Detailed Site Plan Alternative Compliance Parliament Place

DSP-20024
AC-20011

SUBJECT: Detailed Site Plan DSP-20024
Type 2 Tree Conservation Plan TCP2-033-2020
Alternative Compliance AC-20011
Parliament Place

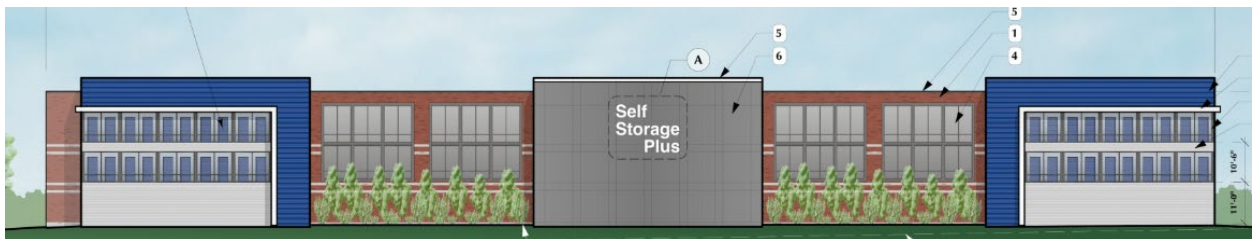
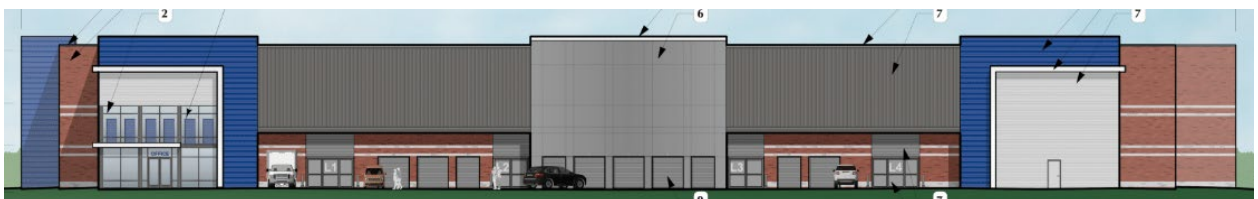
The proposed, approximately 151 foot by 301 foot, three-story, 128,383-square-foot, 1,042-unit building will be a maximum of 36 feet in height. This consolidated storage building presents a balanced composition of masonry block, exterior insulated finish system, horizontal blue metal panels, and storefront glazing. This roughly rectangular building is proportionally divided into smaller forms to minimize visual impact by providing projections, mixed materials, and color patterns.

The office will be located on the southeast corner of the building, at the entrance to the site, and is distinguished by two stories of storefront fenestration, framed with the blue metal panels and white trim. Above the entrance will be a decorative display showing blue storage doors. It is important to note that these storage doors, as well as storage doors shown on other exterior elevations, are purely decorative, will not function as individual storage units, and will not be accessible by customers. This is a typical feature with many consolidated storage facilities developed throughout the County. The entrance to the interior storage units will be from four locations along the northeast elevation, identified numerically on the storefront fenestration. In addition, 10 individual units can be accessed directly from the parking and loading area, and also along the northeast elevation. These entrances are not visible from any street.
